January 14, 2008

ULNRC-05463

**DOCKET NUMBER 50-483  
CALLAWAY PLANT UNIT 1  
UNION ELECTRIC CO.  
REVISION TO TECHNICAL SPECIFICATION  
REGARDING CONTROL ROOM ENVELOPE HABITABILITY IN  
ACCORDANCE WITH TSTF-448, REVISION 3, USING THE  
CONSOLIDATED LINE ITEM IMPROVEMENT PROCESS  
(LICENSE AMENDMENT REQUEST OL-1287)**

3.7.10 Control Room Emergency Ventilation System (CREVS)

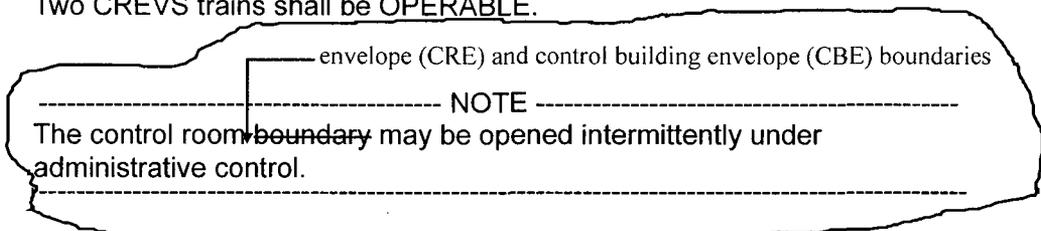
CONDITION	REQUIRED ACTION	COMPLETION TIME
A. One CREVS train inoperable/ <sup>↑</sup> for reasons other than Condition B.	A.1 Restore CREVS train to OPERABLE status.	7 days
B. Two CREVS trains inoperable due to inoperable control room boundary in MODES 1, 2, 3, and 4. Insert 3.7.10.B	B.1 Restore control room boundary to OPERABLE status.	24 hours
C. Required Action and associated Completion Time of Condition A or B not met in MODE 1, 2, 3, or 4.	C.1 Be in MODE 3.	6 hours
	<u>AND</u> C.2 Be in MODE 5.	36 hours

3.7.10 Control Room Emergency Ventilation System (CREVS)

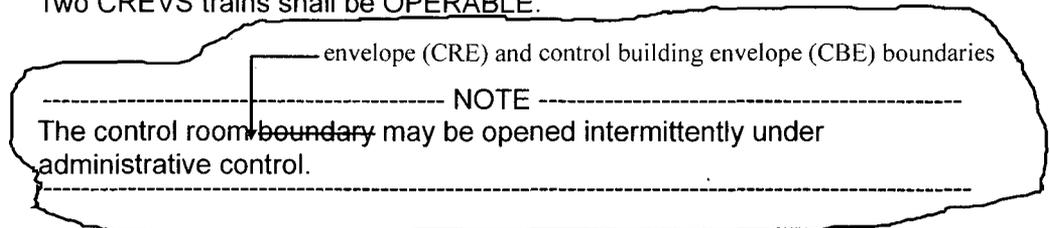
CONDITION	REQUIRED ACTION	COMPLETION TIME
for reasons other than Condition B: A. One CREVS train inoperable/↑	A.1 Restore CREVS train to OPERABLE status.	7 days
B. Two CREVS trains inoperable due to inoperable control room boundary in MODES 1, 2, 3, and 4. Insert 3.7.10.B	B.1 Restore control room boundary to OPERABLE status.	24 hours
C. Required Action and associated Completion Time of Condition A or B not met in MODE 1, 2, 3, or 4.	C.1 Be in MODE 3.	6 hours
	AND C.2 Be in MODE 5.	36 hours

INSERT 3.7.10.B

<p>B. One or more CREVS trains inoperable due to an inoperable CRE boundary or an inoperable CBE boundary in MODE 1, 2, 3, or 4.</p>	<p>B.1</p>	<p>Initiate action to implement mitigating actions.</p>	<p>Immediately</p>
	<p><u>AND</u></p>		<p>24 hours</p>
	<p>B.2</p>	<p>Verify mitigating actions to ensure CRE occupant radiological exposure will not exceed limits and CRE occupants are protected from chemical and smoke hazards.</p>	
<p><u>AND</u></p>			
	<p>B.3</p>	<p>Restore the CRE boundary and CBE boundary to OPERABLE status</p>	<p>90 days</p>
